Subject: Additional Information Concerning Alternate Waste Disposal (License No. SNM-00033, Docket No. 070-00036)

Summary of Hydrogeologic Conditions and Groundwater Flow Model

**US Ecology Idaho Facility
Grand View, Idaho**

6 APPENDIX B: Response to CCI Issues

L-38 Hydrograph

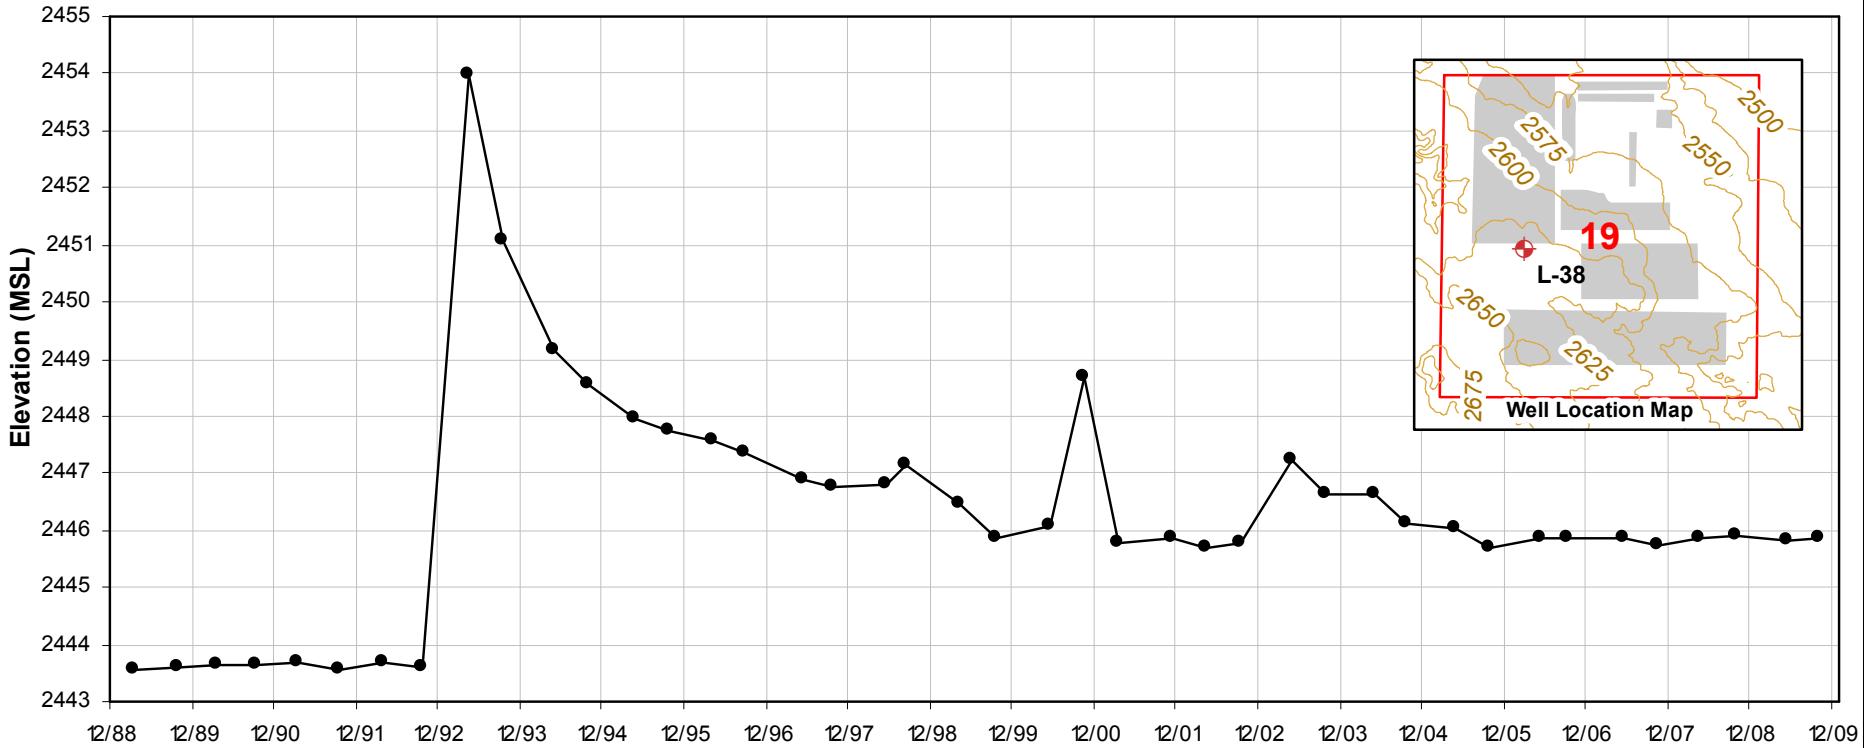
See Section 3.1 of this response document and responses to Issues 1, 2, and 3. Furthermore, the rise in the potentiometric surface at well L-38 in 1992 was in direct response to the geologically sudden increase in surface loading as the spoils from the excavation of trench 14 were stockpiled adjacent to this well. For the next 10 years water levels slowly recovered (declined) as the aquifer reached a new equilibrium with this loading. In 2002 additional spoils were moved into the area causing another small increase with a commensurate gradual decline for about 3 years. Since 2005 water levels in this well have been approximately constant. Other Lower Aquifer wells in the vicinity of Cells 14 and 15 also show rapid water level variations apparently related stockpiling and moving of spoils and the excavating and filling of trenches. Lower Aquifer wells more distant from the construction activity do not show these variations. The author should review the concept of hydraulic soil loading and effective stress on confined aquifer systems.
